Access Compliance Report Public Rights-of-Way (Curb Ramps)

Main Street: NARROW_CANYON_RD		Cross Street: EPONA_WAY		Location:	S
ADA ID: RPRK211027143251	Ramp Type: Type 4 - Parallel	Initial Pass/Fail: Fail	Overall Compliance: No	Severity Score:	16

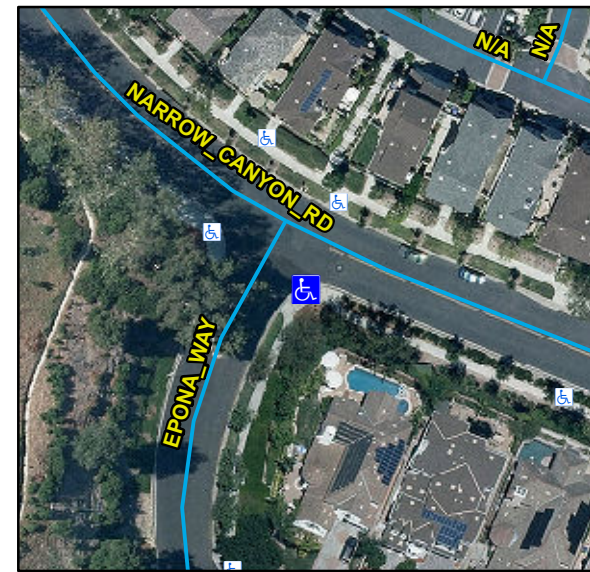
Compliance	Description	Data	Compliance	Description	Data
N/A	Ramp Length LT (in)	134	N/A	Ramp Length RT (in)	134
Yes	Ramp Width LT (in)	89	Yes	Ramp Width RT (in)	88
Yes	Ramp Run Slope LT (%)	1.9	No	Ramp Run Slope RT (%)	9.7
No	Ramp Cross Slope LT (%)	2.8	Yes	Ramp Cross Slope RT (%)	0.4
N/A	Landing Present	N/A	N/A	DWS Provided	N/A
N/A	Landing Length (in)	N/A	N/A	DWS Contrast	N/A
N/A	Landing Width (in)	N/A	N/A	DWS Length (in)	N/A
N/A	Landing Run Slope (%)	N/A	N/A	DWS Full Width	N/A
N/A	Landing Cross Slope (%)	N/A		DWS Offset Type	N/A
N/A	Landing Movement Obstructed?	N/A	N/A	DWS Offset Left (in)	N/A
	Landing Movement Type	N/A	N/A	DWS Offset Right (in)	N/A
N/A	Landing Shared	N/A			
N/A	Clear Space	Yes			
N/A	Clear Space To Crosswalk (in)	N/A			
N/A	Marked Crosswalk 1	No	N/A	Marked Crosswalk 2	No
	Crossing 1 Direction	NE		Crossing 2 Direction	NW
	Marked Crosswalk 1 Width (in)	N/A		Marked Crosswalk 2 Width (in)	N/A

N/A	Ramp Inside Crosswalk 1	N/A	N/A	Ramp Inside Crosswalk 2	N/A
	Crossing 1 Slope (%)	4.8		Crossing 2 Slope (%)	3.7
	Crossing 1 Cross Slope (%)	2.4		Crossing 2 Cross Slope (%)	3.6
N/A	Gutter Ponding	N/A	N/A	Curb Slope	7.3
Yes	Gutter Lip Height (in)	0		Road Run Slope (%)	1.8
N/A	Gutter Run Slope (%)	N/A		Road Cross Slope (%)	0.7
N/A	Gutter Cross Slope (%)	N/A	No	Perpendicular Joint Present	No
Yes	Overall Surface Condition	Acceptable			
	Cross Gutter Present?	No		Spandrel Present?	No
	Replace Cross Gutter?	N/A		Replace Spandrel?	N/A

Remove & Replace Curb Ramp With Two New Directional Ramps or Equivalent.
